November 25, 2002

L-2002-221  
10 CFR 50.90

RE: St. Lucie Unit 1  
Docket No. 50-335  
Proposed License Amendment  
Spent Fuel Pool Soluble Boron Credit

Figure 5.6-1  
 Allowable Region 1 Storage Patterns and Fuel Alignments

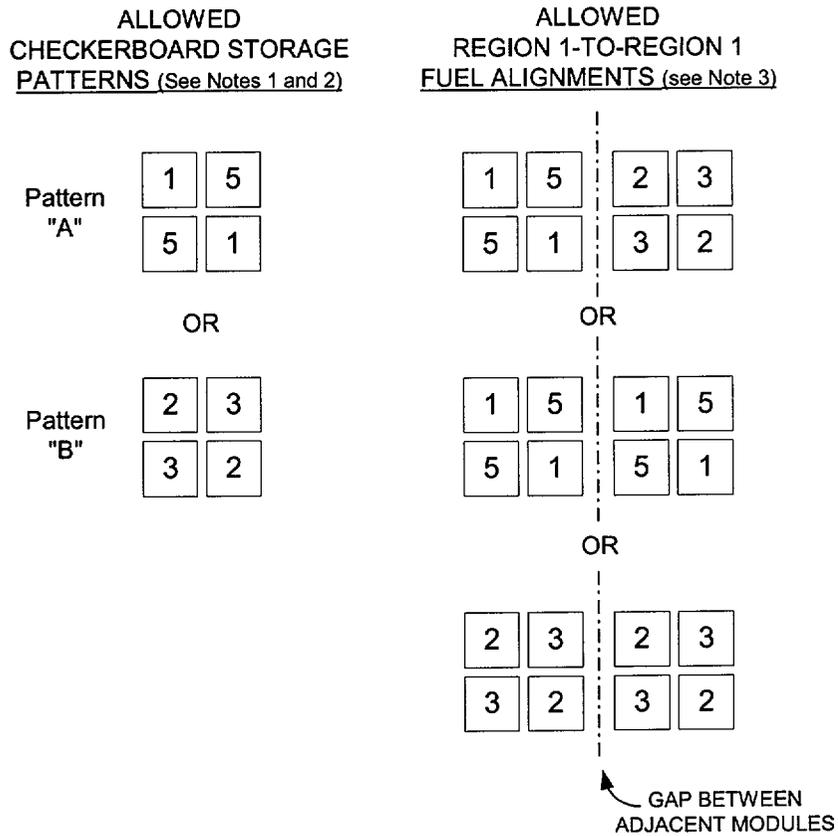
- i. **Figure 5.6-1:** The existing figure would be deleted and replaced with new Figure 5.6-1, "Allowable Region 1 Storage Patterns and Fuel Alignments," and **Figure 5.6-2,** "Allowable Region 2 Storage Patterns and Arrangements." The new figures describe the checkerboard loading patterns and restrictions imposed by TS 5.6.1.b.
- j. **New Tables 5.6.1,** "Minimum Burnup as a Function of Enrichment for Non-Blanketed Assemblies," and **5.6.2,** "Minimum Burnup as a Function of Enrichment for Blanketed Assemblies," would be added. The new tables define the minimum burnup requirements for the seven new spent fuel types called out in new Figures 5.6-1 and 5.6-2.
- k. **TS 3/4.9.11 Bases** would be revised to reflect changing the section title and adding the SFP boron concentration LCO.

2. For adjacent Region 1 rack modules, checkerboard patterns A and B must be aligned across the gap between the modules such that a high reactivity fuel assembly on one side of the gap must face a low reactivity assembly across the gap. This restriction is shown by the allowed Region 1-to-Region 1 fuel alignment requirements on new TS Figure 5.6-1.

2. Fuel placed in Region 1 of the spent fuel pool storage racks shall comply with the storage patterns and alignment restrictions of Figure 5.6-1 and the minimum burnup requirements of Table 5.6-1 and Table 5.6-2.

1. Numbering denotes fuel assembly type. Minimum burnup requirements for fuel assembly types 1, 2, 3, and 5 are defined in Tables 5.6-1 and 5.6-2.
2. The storage arrangement of fuel within a rack module may contain more than one pattern. Different fuel storage patterns within a rack module must be separated by an empty row of cells.
3. Interface restrictions on fuel placement apply between adjacent Region 1 rack modules. No interface restrictions apply between Region 1 racks and adjacent Region 2 racks.
4. Open cells within any checkerboard pattern are acceptable.

Figure 5.6-2  
 Allowable Region 2 Storage Patterns and Arrangements

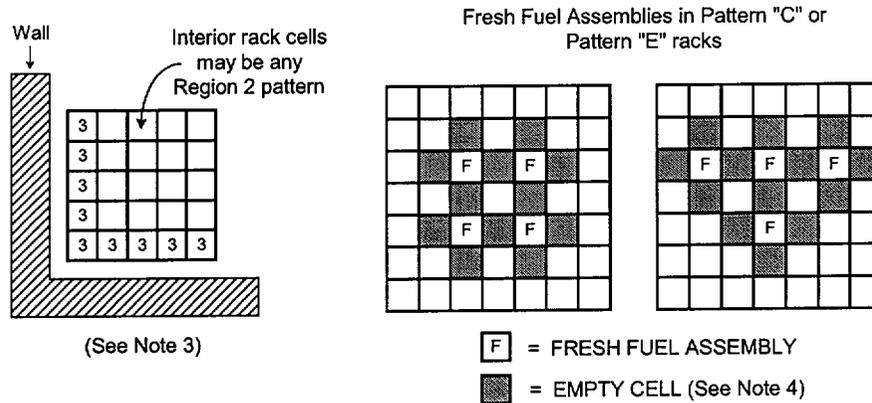
4. For Region 2 racks facing the pool wall or the cask pit wall, the outer row of cells facing the wall is qualified to accept assemblies meeting the burnup and enrichment requirements for Type 3 fuel assemblies, and need not contain a CEA, regardless of the fuel assembly characteristics in the remainder of the Region 2 rack. The permissible configuration is shown in new TS Figure 5.6-2.

5. Fresh fuel assemblies can be placed within a Pattern C or Pattern E configuration in a Region 2 storage rack module, as long as each fresh assembly directly faces 4 empty cells, and each of the diagonal cells is either empty or contains a Type 4, 6, or 7 assembly. A fuel rod basket may be substituted for any fresh fuel assembly. Empty cells may contain non-actinide material, such as an empty fuel assembly skeleton, or other hardware, so long as the material occupies no more than 75% of the cell volume. These configurations are shown in new TS Figure 5.6-2.

The new criticality analysis credits the reactivity suppression provided by full strength CEAs for Region 2 loading Pattern "D," as shown in new TS Figure 5.6-2. In this pattern, the CEAs are checkerboarded in Type 3 fuel assemblies (i.e., assemblies containing CEAs are diagonal to each other) throughout the rack.

3. Fuel placed in Region 2 of the spent fuel pool storage racks shall comply with the storage patterns or allowed special arrangements of Figure 5.6-2 and the minimum burnup requirements of Table 5.6-1 and Table 5.6-2. The allowed special arrangement for fresh fuel may be repeated, provided the applicable interface requirements specified by the safety analysis are met.

1. Numbering denotes fuel assembly type. Minimum burnup requirements for fuel assembly types 3, 4, 6, and 7 are defined in Tables 5.6-1 and 5.6-2.
2. The storage arrangement within a rack module may contain more than one checkerboard pattern (patterns "C," "D," or "E") provided an empty row of cells separates the patterns.
3. Fuel in peripheral cells need not contain CEAs. An empty row of cells separating these peripheral cells from the interior pattern is not required. Cells on the Region 2 periphery that form interior corners do not qualify for this arrangement.
4. Cells required to be empty as part of an allowed special arrangement may contain non-actinide material, such as an empty fuel assembly skeleton, as long as the material occupies no more than 75% of the cell volume.
5. Open cells within any checkerboard pattern are acceptable.

**FIGURE 5.6-1**  
**Allowable Region 1 Storage Patterns and Fuel Alignments**

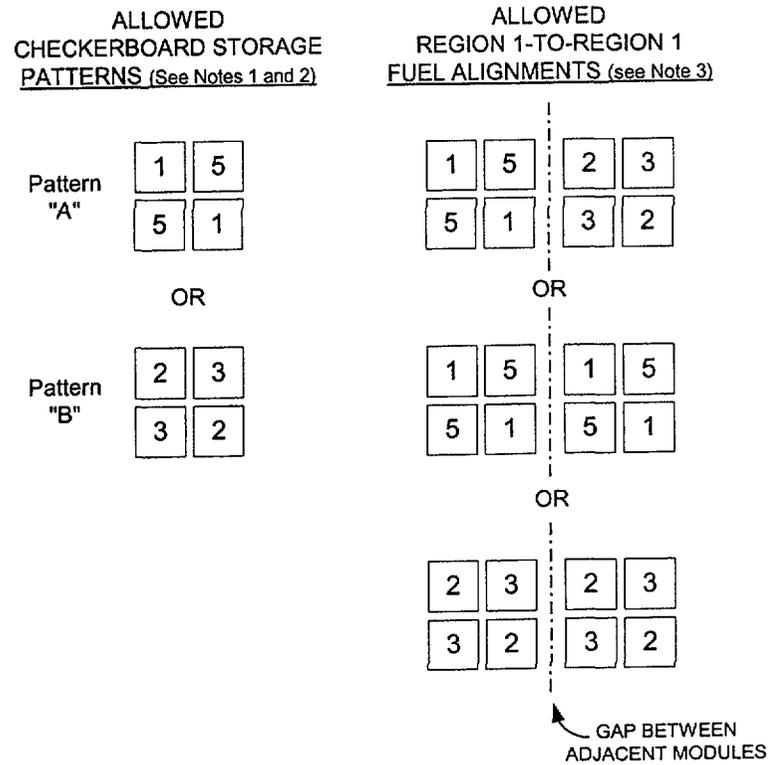
2. Fuel placed in Region 1 of the spent fuel pool storage racks shall comply with the storage patterns and alignment restrictions of Figure 5.6-1 and the minimum burnup requirements of Table 5.6-1 and Table 5.6-2.

FIGURE 5.6-2  
Allowable Region 2 Storage Patterns and Arrangements

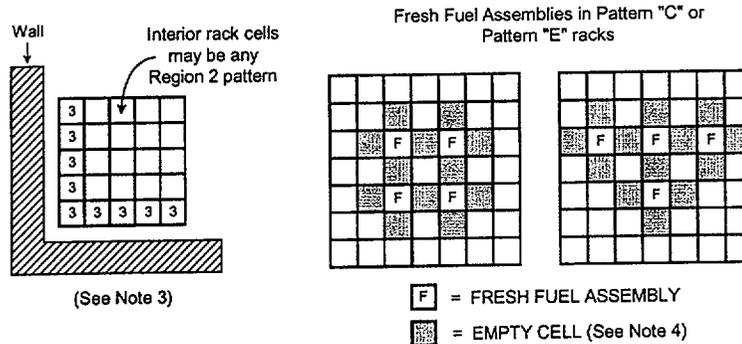
3. Fuel placed in Region 2 of the spent fuel pool storage racks shall comply with the storage patterns or allowed special arrangements of Figure 5.6-2 and the minimum burnup requirements of Table 5.6-1 and Table 5.6-2. The allowed special arrangement for fresh fuel may be repeated, provided the applicable interface requirements specified by the safety analysis are met.
